## SOLAR INDUSTRIAL ESTATE - HAWKSWORTH / THOROTON

Public Inquiry - Independent Person Submission by Thoroton resident - Colin Warburton.

PINS Appeal: APP/P3040/W/23/3330045

LPA Ref: 22/02241/FUL.

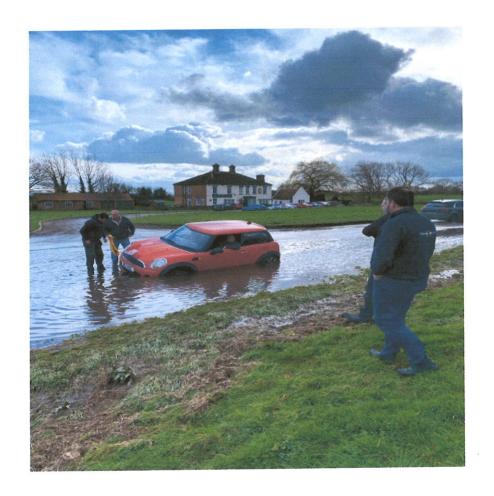
I would suggest that to permit up to 40 heavily laden vehicles per day to use narrow unlit rural roads with no footpaths is unsafe and in breach of the Road Traffic Act and Highway Code. The roads from the old A46 to the proposed construction site are in use at all times of the year not just by local residents of the immediate communities but also by hundreds of visitors to the area and that a restriction of this right to use the roads for walking, cycling, horse riding, running etc is a demonstration of loss of amenities. I would further suggest that no proposed Traffic Management Plan which includes road closures, one way traffic systems etc will alleviate the identified problems. It should be further noted that in addition to the forty heavily laden lorries per day there will be up to fifty construction workers at the proposed Solar site. These workers will have to travel to and from the site on a daily basis and will add to the traffic congestion. Attached is a photograph showing a lorry on Longhedge Lane near to the proposed site entrance which clearly identifies the limited space at the side of the vehicle.
